TRANS/WP.29/GRSG/2002/7  
29 July 2002

PROPOSAL FOR DRAFT AMENDMENTS TO REGULATION No. 107

(Double-deck large passenger vehicles)

Transmitted by the Expert from Germany

"Figure 10

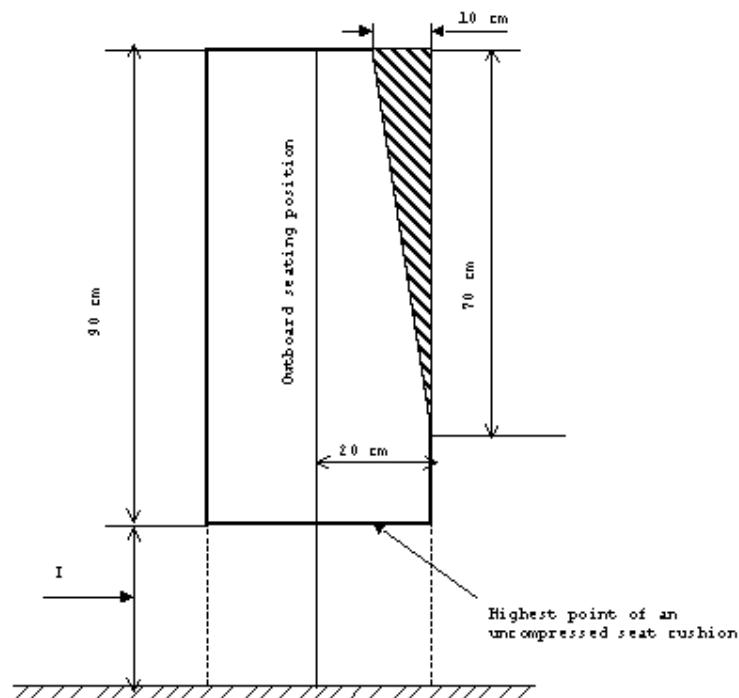
"5.7.9.6.2.2. Intrusion of a structural member provided that the intrusion is included within a triangle whose peak is situated ~~65 cm~~ **70 cm from the top** and whose base is 10 cm in width and situated in the upper part of the space in question, adjacent to the side wall of the vehicle (see annex 3, figure 10)"

Annex 3, Figure 10, amend to read:

The alteration corrects figure 10. The requirements of figure 6 for the "I" value are also transferred to figure 10 to make clear that the general prescriptions of paragraph 5.7.9.3. also apply to paragraph 5.7.9.6.2.2.

As there are different values for "I" the former method to define the starting point for the triangle representing the permitted intrusion needs to be revised, in order to establish equal conditions for all of the different values. Measuring from the top of the minimum height above the seat and leaving the geometry of the triangle unchanged achieves this.
